NTUA Headquarters Complex Office Building

Dyron Murphy Architects Project No. 2015.05

ADDENDUM No. 3

November 11, 2016

ALUMINUM STOREFRONT SYSTEM
 GLAZING: IG-1
 ELEVATION E5/A203 (OFFICES 1428-1431)
 ADDENDUM NO. 3

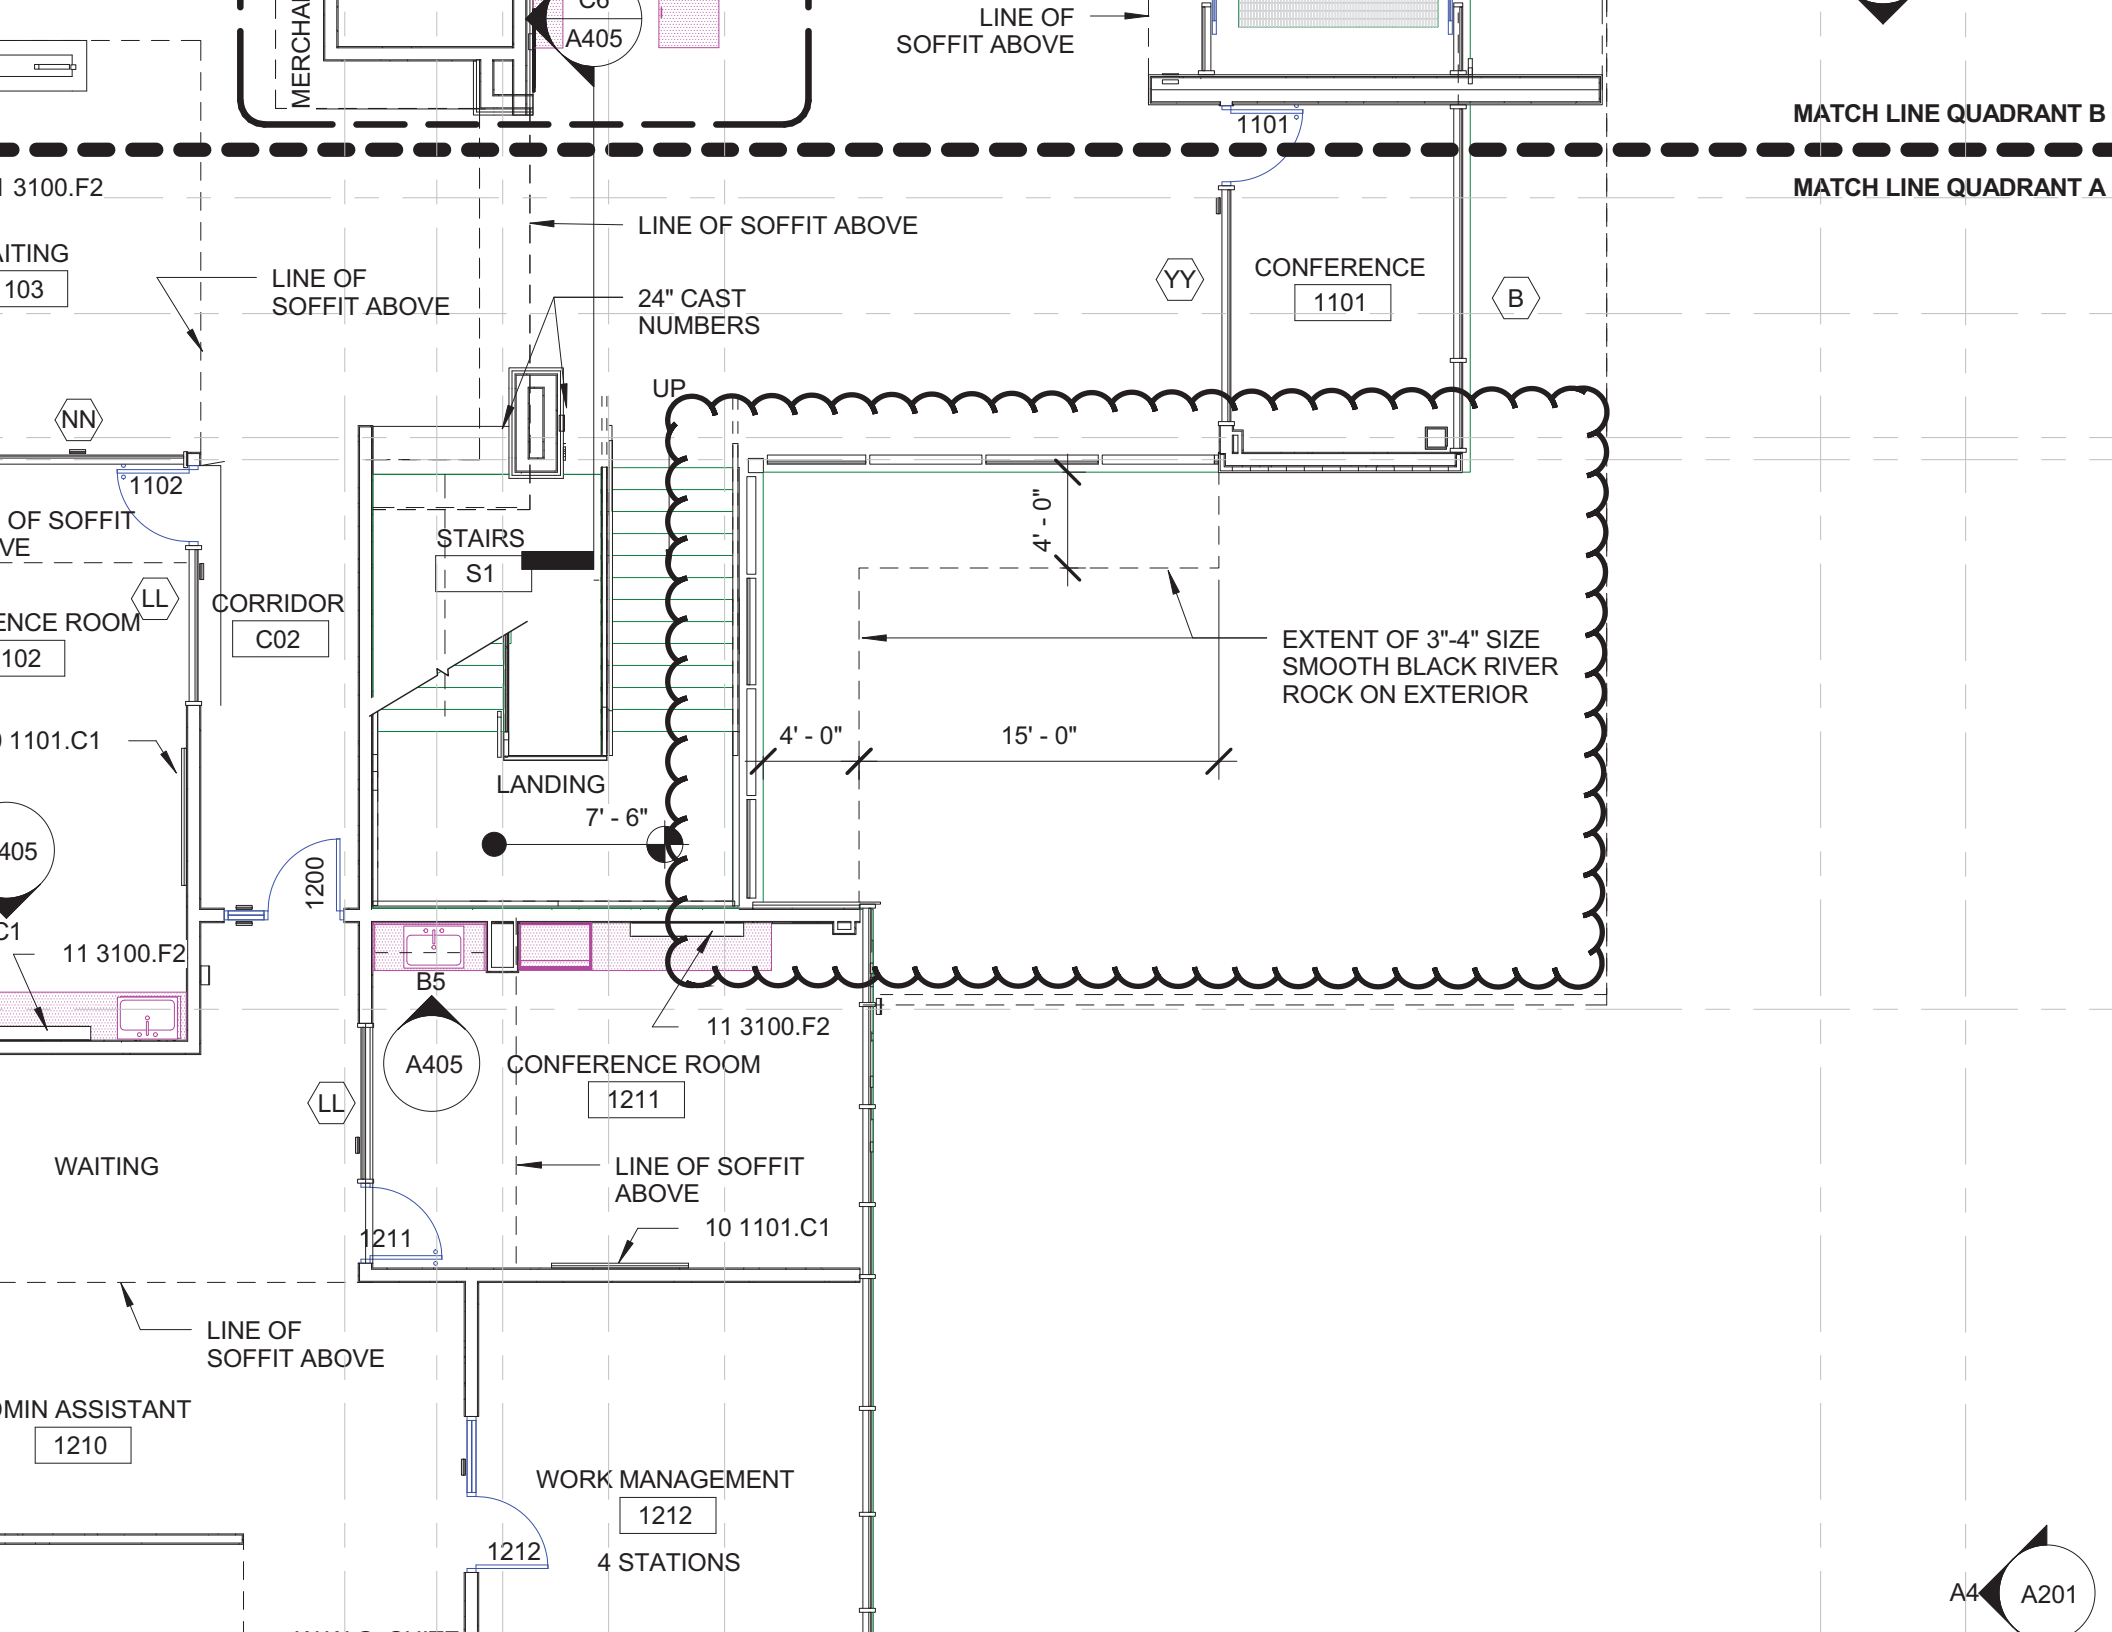
6. There is a window type at exterior wall of Offices 1428 thru 1431 which has no tag (lower right of elevation E5/A203)?

Window type is missing from Window Types. Refer to attached sketch with required dimensions and information.

14. Sheet A101A note indicates to "provide 3"-4" size smooth black river rock below all of stair S1, 3" deep. Coordinate with landscaping where black river rock extends to exterior. I do not see where the landscape plans address this item. Please provide sketch to define area of black river rock.

Refer to attached sketch for extent of river rock on the exterior.

Sheet Title: MECHANICAL 1st FLOOR HVAC PLAN - QUADRANT B

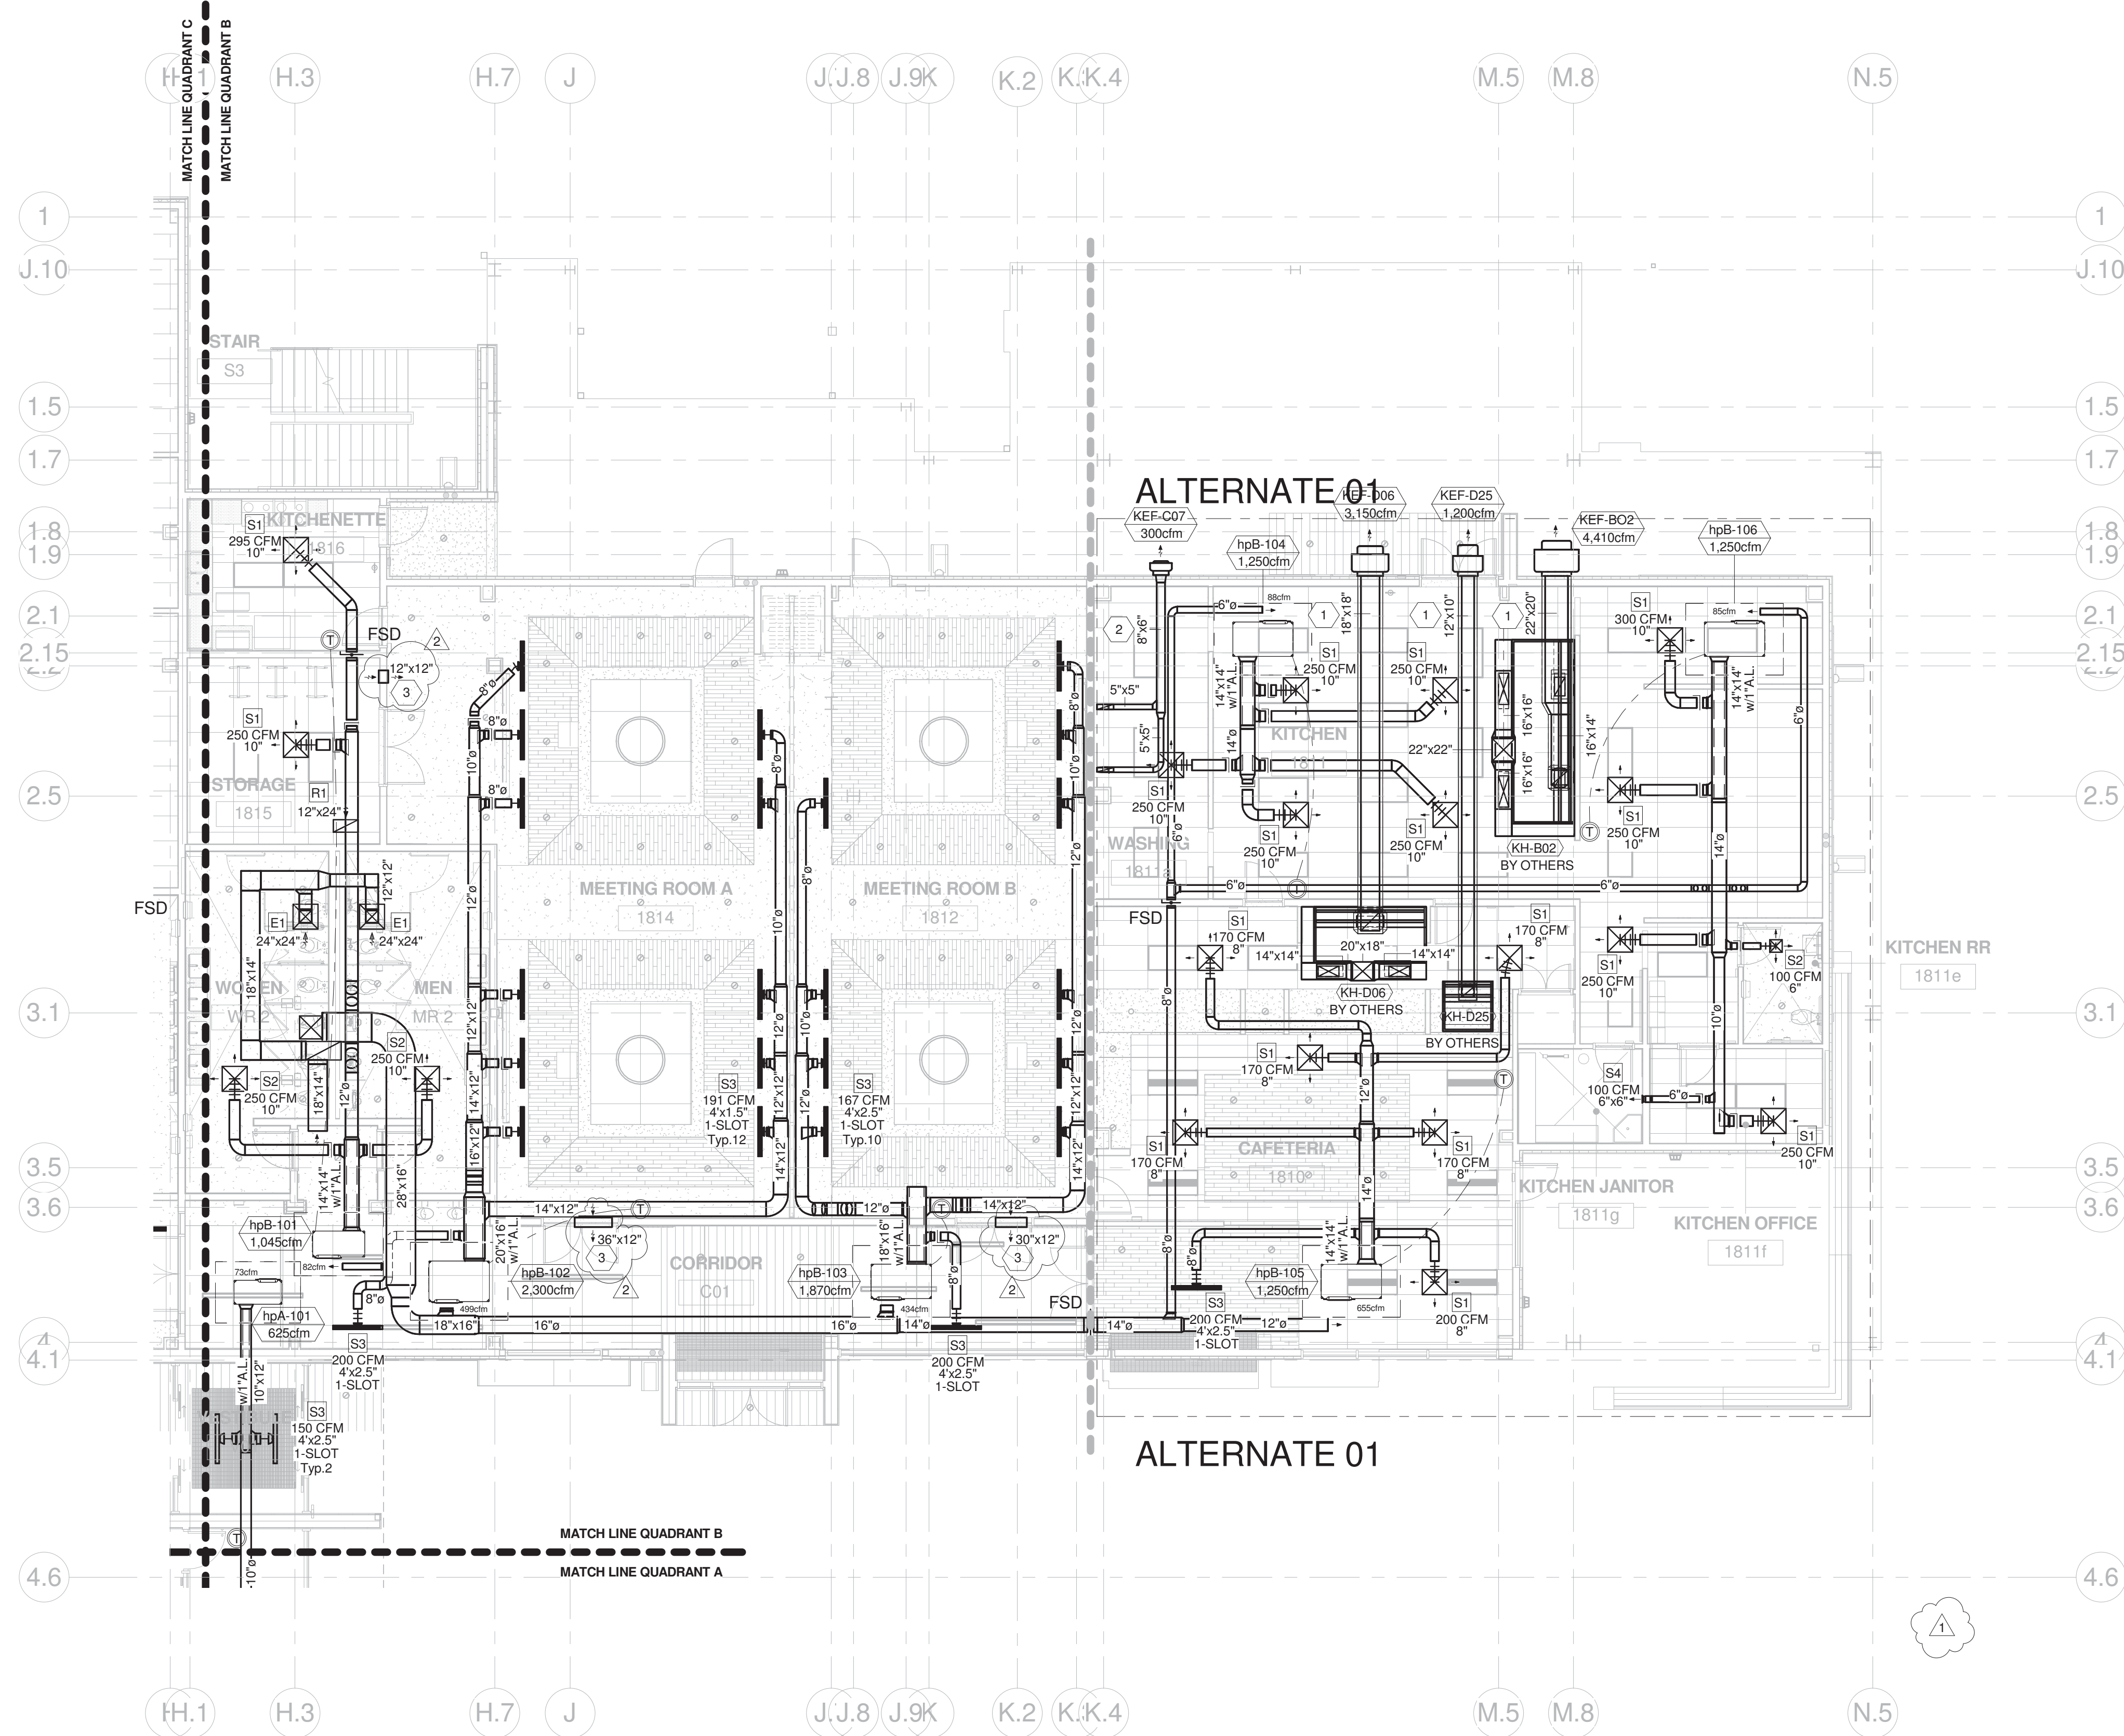
DOCUMENT:	DESCRIPTION:
Drawing M003 MECHANICAL EQUIPMENT SCHEDULES	- ADDS: At WSHP Schedule: SMOKE DETECTORS AT ALL UNITS DUCTED FILTER RACK SECTION – FACTORY PROVIDED
Drawings M101a M101b M101c M102a M102b M102c MECHANICAL HVAC PLANS	- ADDS: RETURN AIR OPENINGS THRU WALLS, ABOVE CEILINGS.
Drawing M104 MECHANICAL HVAC PLAN ADDITIVE ALT #02	- ADDS: MECHANICAL HEAT PUMP WATER PIPING
Drawing M501 MECHANICAL BUILDING AUTOMATION SYSTEM	- ADDS: Detail M1 / M501: Electrical Power Monitor – NORMAL / EMERGENCY Detail M4 / M501: Outdoor Air Temperature (dry-bulb and wet-bulb)
Drawing M502	- REVISES: Detail M2 / M502 – revises ERV Points List Schedule

CONDENSATE DRAIN AT TRAP DETAIL
NOT TO SCALE

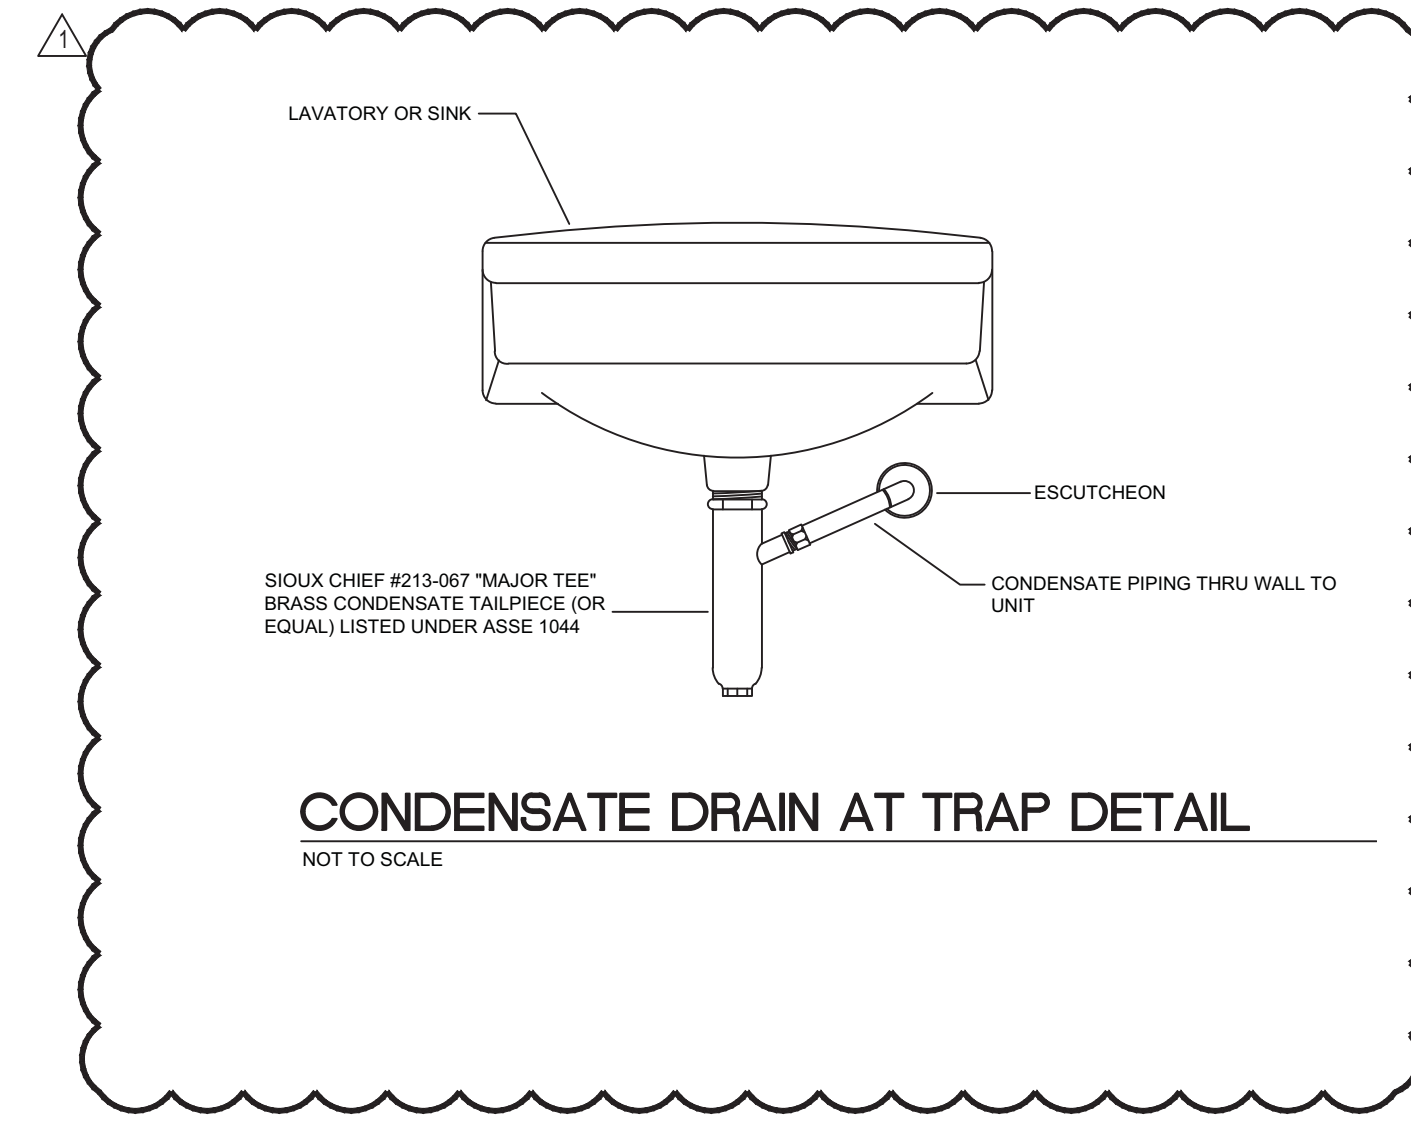
Drawing P304 PLUMBING FITNESS CENTER ADDITIVE ALT #02	<ul style="list-style-type: none"> - ADDS: Condensate piping for Water Source Heat Pump Units
Drawing P401 PLUMBING DETAILS	<ul style="list-style-type: none"> - ADDS: Condensate drain at trap for Lav detail - REVISES: Water Heater Flue Vent Detail
